# Construction question

# Proposed Grounding Conceptual Drawing

DUNE Far Detector Conceptual Grounding Diagram (1 of 4 Caverns)  
 LBNF/DUNE Steve Chupe 12-12-2017 1 of 1 8

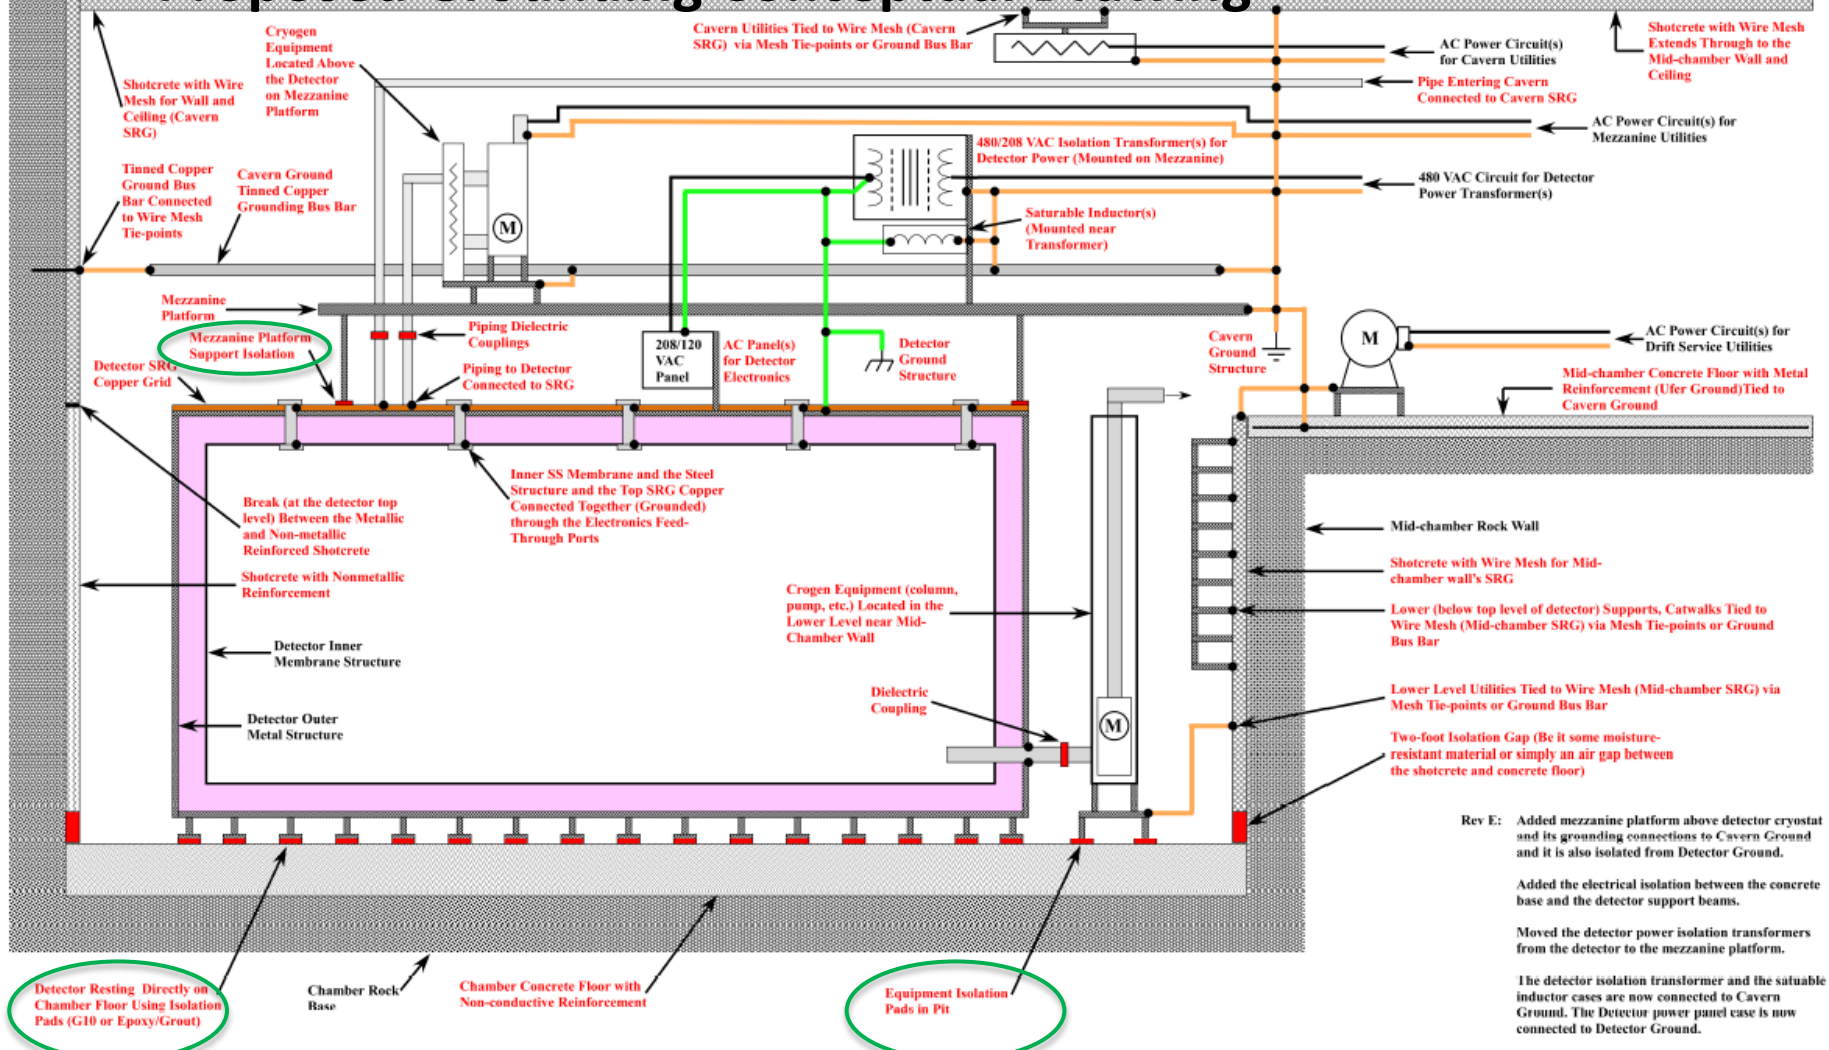
- Is it possible to incorporate a thin piece of G10/coating of epoxy on the beam bottoms and use an epoxy grout (both have high resistivity) during construction?

Idea is that we could use epoxy grout and maybe coat beam bottoms or concrete with epoxy.

**ALSO - Can we use vapor barrier between rock and concrete pour to make sure we keep additional moisture out of concrete?**

... Epoxy has excellent dielectric properties (including volume resistivity values of  $10^{12}$  ohm-cm and greater, a high dielectric strength) and high compressive strength, as well. It is commonly used in civil construction and available for a number of applications, including as a grout and as a floor coating. ...
